**SMALL ARMS RANGE TRAINING AREA
 ENVIRONMENTAL SCREENING-LEVEL ASSESSMENT
 AT FORT JACKSON, SOUTH CAROLINA**

SUBJECT: Submittal of the Final Small Arms Range Training Area Environmental Screening
Level Assessment at Fort Jackson, South Carolina Report for TRMS 9-CO-160-000-504

**ATC Response to USAEC Comments on
Small Arms Range Training Area Environmental Screening-Level
Assessment At Fort Jackson, South Carolina, May 2004**

Figure 3-5. Proximity of Train Fire Road with Respect to Small arms Range

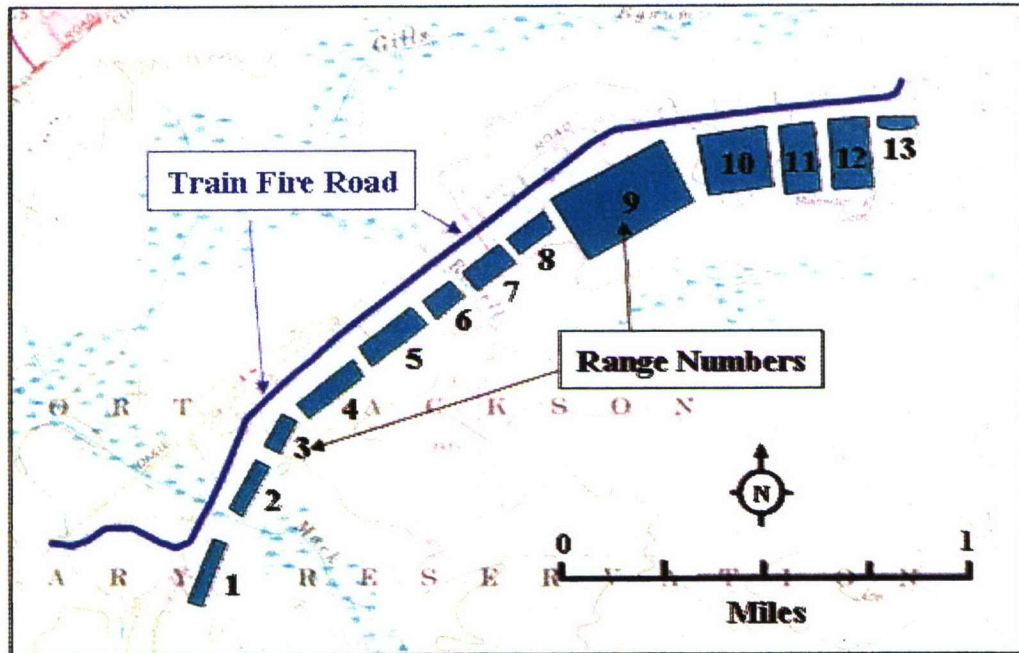
22	Page 17, Figure 3-5	Change "Firetrain Road" to "Train Fire Road" on this figure	Comment incorporated
23	Page 47, Section 6	The current title of this section is "Conclusion for Fort Jackson Small Arms". It should probably be "Conclusions for Fort Jackson Small Arms Ranges"	Comment incorporated
24	Page 55, Figures 7-3 and 7-4.	Both figures for Range 9 require the same corrections done for Figure 3-14 on page 22.	Comment incorporated

Figure 3-15. Range 10 - Qualification Range.

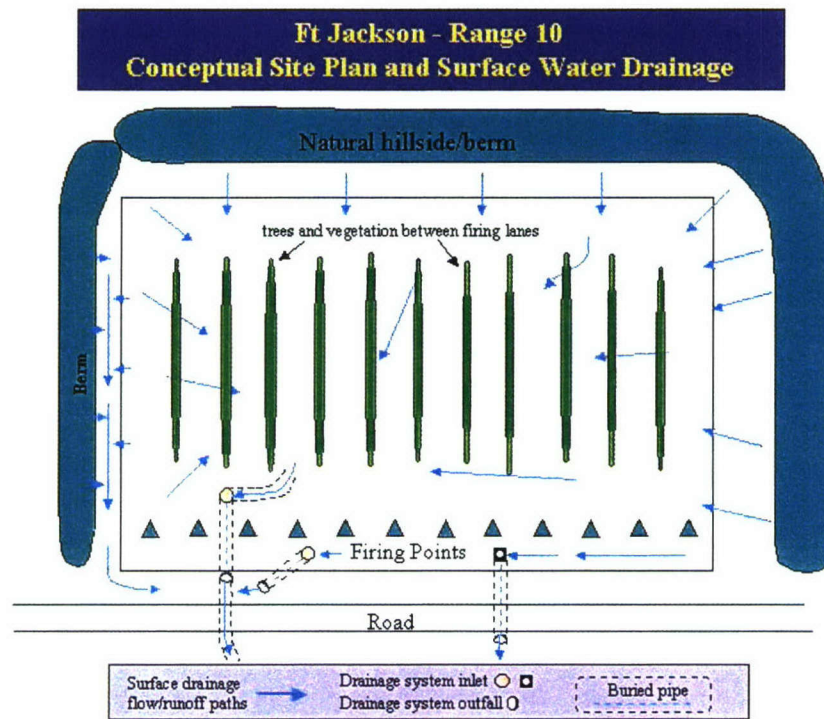
Comment Number	Comment Location	Comment	Response
9	Page 18 1 st full para. Last sentence.	Once again this appears to be an assumption. Reword to say that, "Corrosion is known to occur in environments with..."	The sentence was changed as follows: "An overall estimate of stability as a result of corrosion passivation could not be inferred based on visual observations of the debris. However, corrosion is known to occur in environments with the pH, precipitation, and overall lack of soil nutrient conditions as found at Fort Jackson. These conditions may result in the formation of mobile lead ions."
10	Figures 3-14 and 3-15, page 22.	The depiction of Range 8 on the Range 9 figure does not quite agree with the way it looks on the Range 8 figure. In Figure 3-14, the Range 8 berm extends to the end of the firing lanes, but not to the drainage pipe. In Figure 3-15, it appears to extend past the drainage pipe.	Figure 3-15 has been corrected.
